Regular Planning Commission

Consider Approvals Related to Site Plan Review for Sunwood Village; Case of CommonBond Communities

**CITY OF RAMSEY LAND USE APPLICATION
TECHNICAL REVIEW FILE**

DATE	4/3/15	PROJECT ADDRESS	TBD
PROJECT. TITLE	SUNWOOD VILLAGE (SKETCH PLAN, FINAL PLAT, AND SITE PLAN)		
ESCROW #	114596		
DEPARTMENT:	Community Development: Planning Division (Comprehensive Plan and Zoning Code)		
TECHNICAL REVIEWER:	Name: Chris Anderson, City Planner Phone: 763-433-9817 Email: canderson@cityoframsey.com

Sheet A500

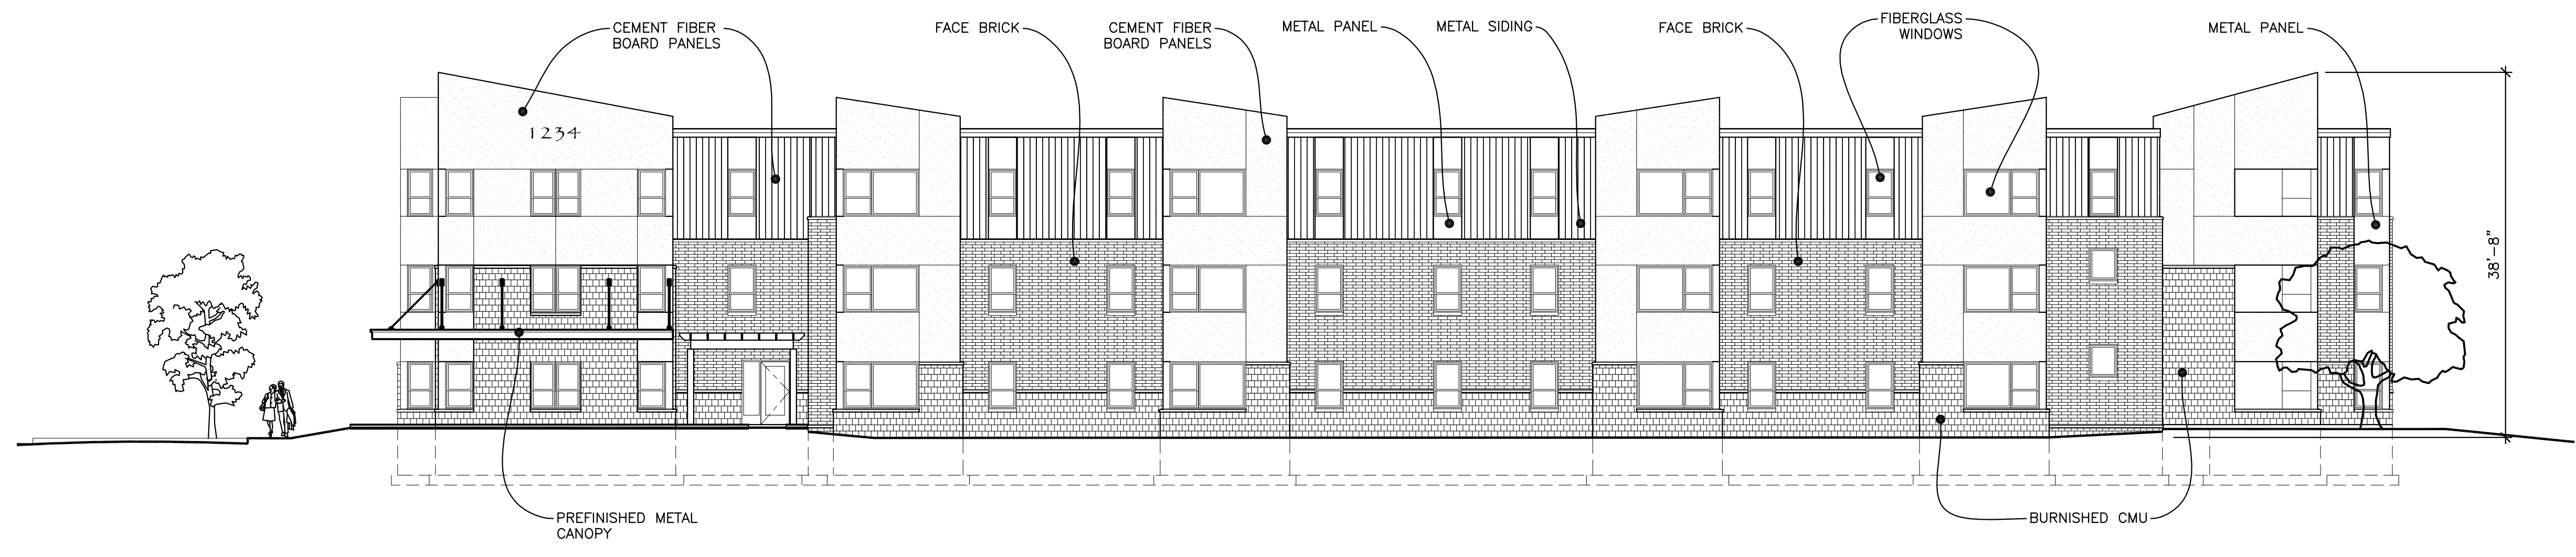
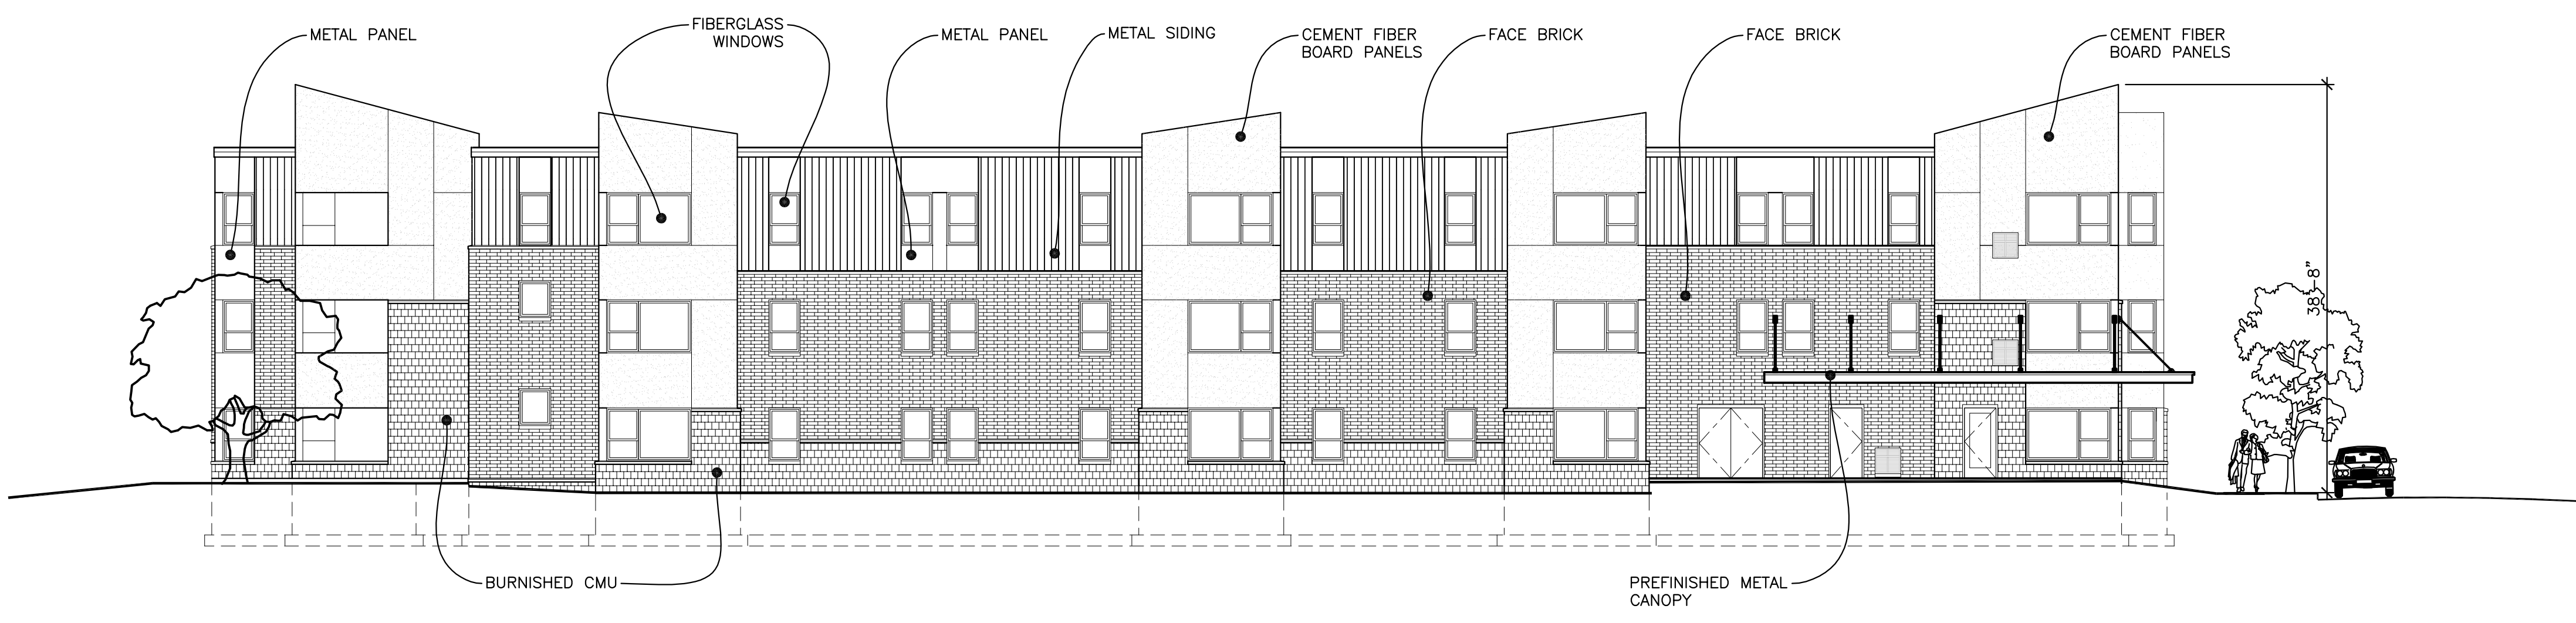
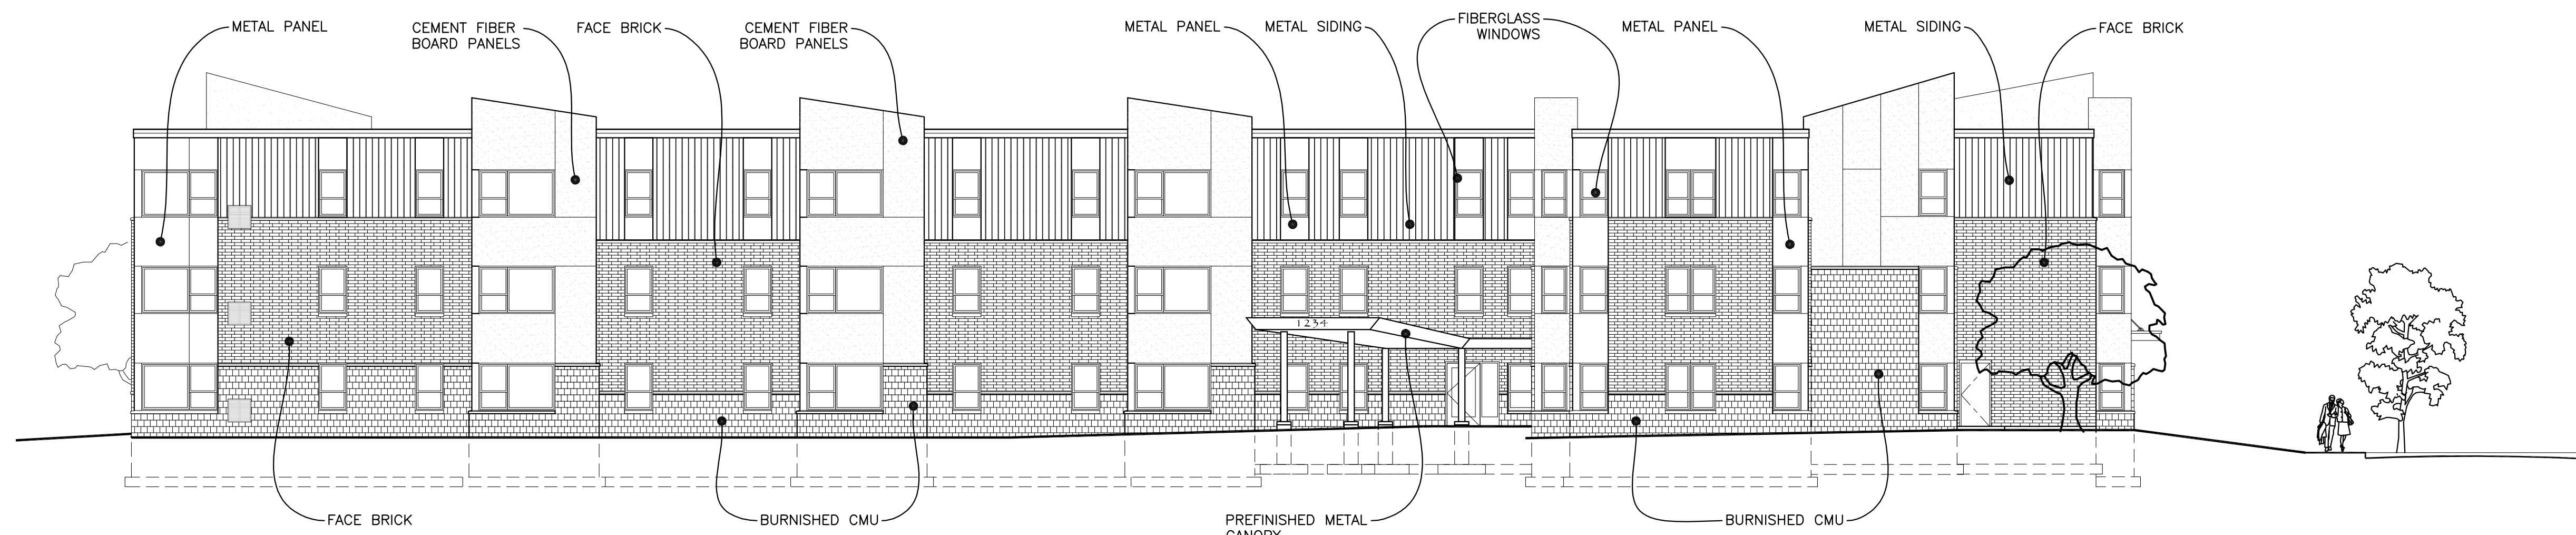
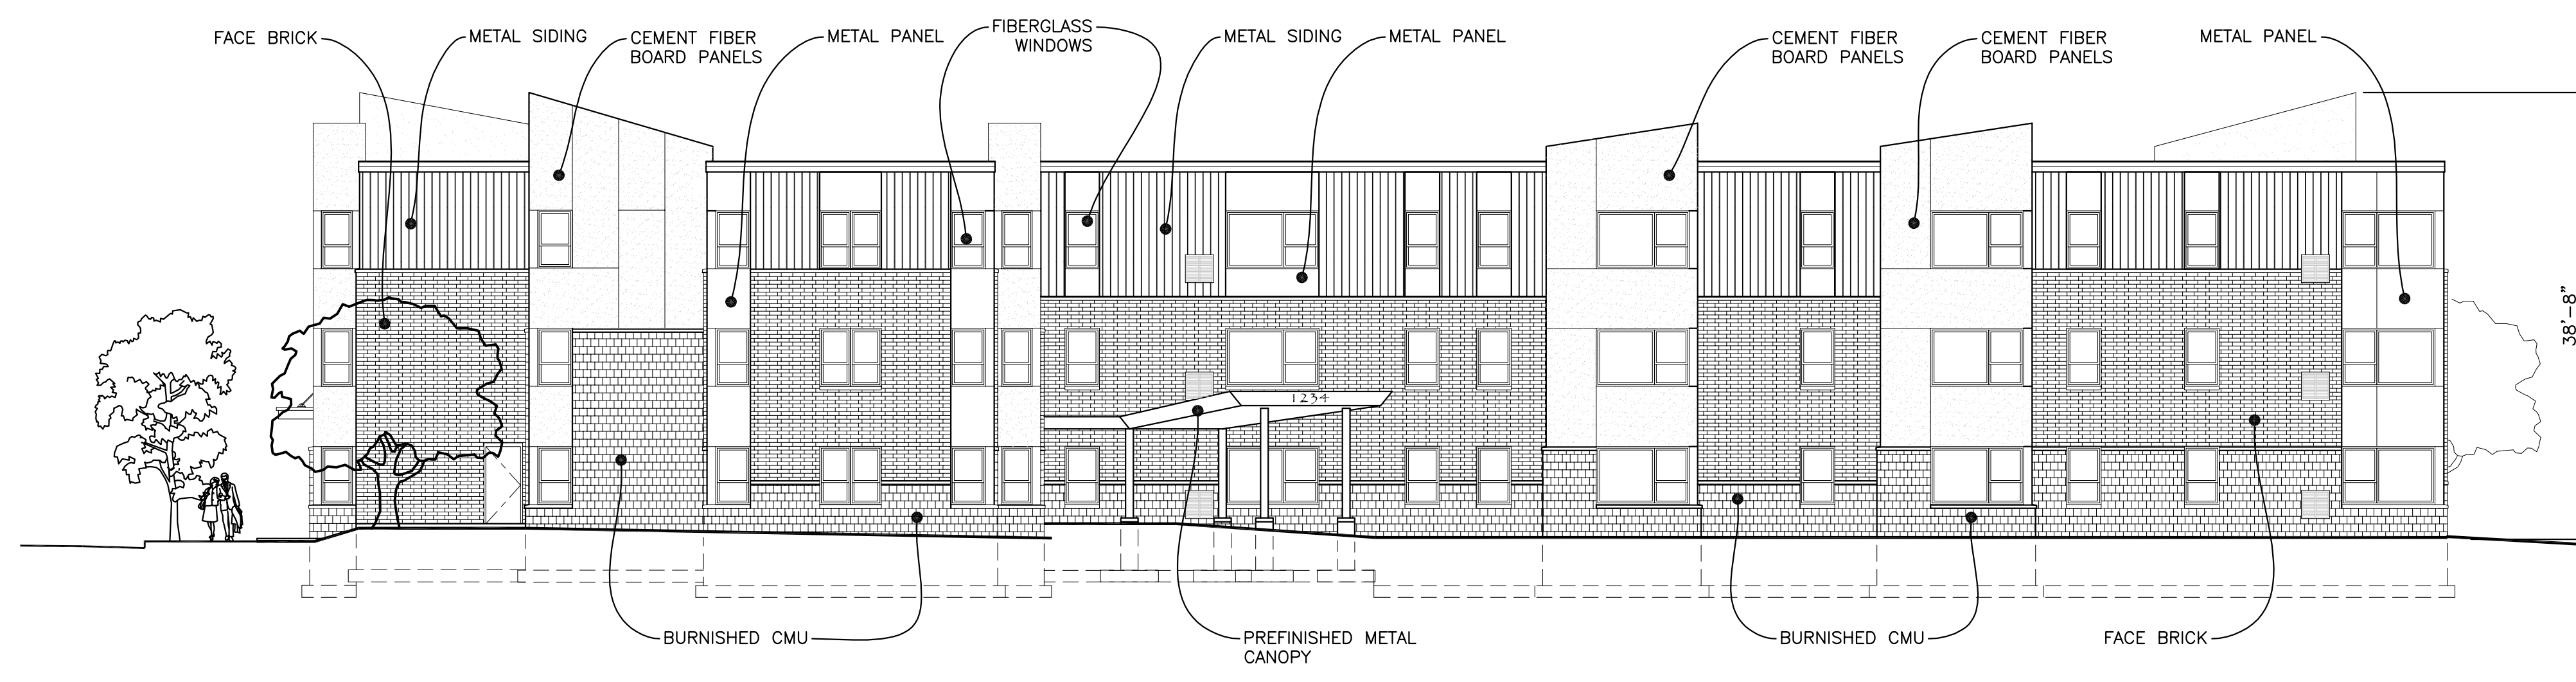
- Provide clarification on why the direct access to the ground floor units facing Sunwood Drive were removed from the plans.
- Provide a calculation for the brick versus the overall façade to verify that the brick is at least fifty percent (50%) of the total non-glazed surface.
